Memorandum Department of Planning & Public Works

To: Planning and Public Works Committee
From: Kristian Corbin, Project Planner
Date: April 19, 2010
RE: Four Seasons Plaza West (National City Bank ATM): An Amended Site Development Plan, Architectural Elevations, and Lighting Plan for a 2.35 acre tract of land zoned "PC" Planned Commercial District located on the southwest corner of the intersection of Olive Boulevard and River Valley Drive.

PLANNING COMMISSION STAFF REPORT

Description: **Four Seasons Plaza West (National City Bank ATM):** An Amended Site Development Plan, Architectural Elevations, and Lighting Plan for a 2.35 acre tract of land zoned “PC” Planned Commercial District located on the southwest corner of the intersection of Olive Boulevard and River Valley Drive.

ATM DETAIL
SCALE 1"=10'

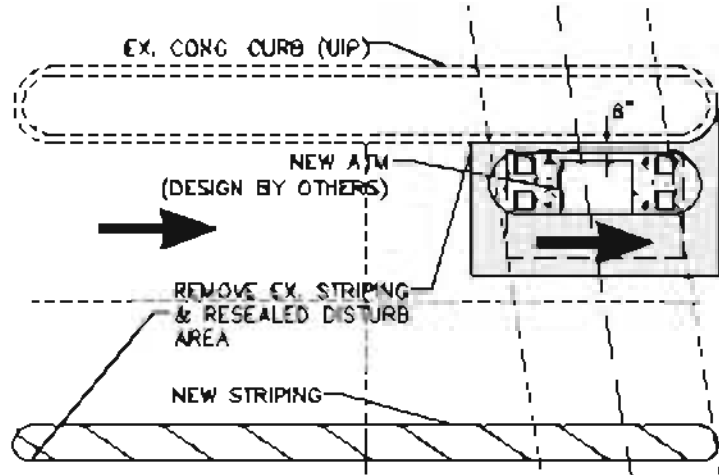
The Architectural Review Board made a recommendation that the island adjacent to the ATM be improved with some low level (30"-36") evergreen shrubbery to provide screening to the back of the ATM. The petitioner worked with Staff and agreed to plant low lying shrubs for screening purpose. The proposed species and design are to be determined and will be submitted to Staff for review prior to approval of any Municipal Zoning Approvals of the ATM. See the petitioner's letter attached in the Planning Commission packet.

1. Recommendation that the island adjacent to the ATM be improved with some low level (30"-36") evergreen shrubbery to provide screening to the back of the ATM.

The petitioner worked with Staff and agreed to add additional landscaping to the site. Evergreen shrubs will be planted along the parking lot island adjacent to the ATM location. See the petitioner's letter attached in the Planning Commission Packet.

This is to verify that we will landscape the island directly next to the proposed ATM. It will be designed to provide screening at the lower level. We will submit a landscape plan to the City, for staff approval, prior to construction.
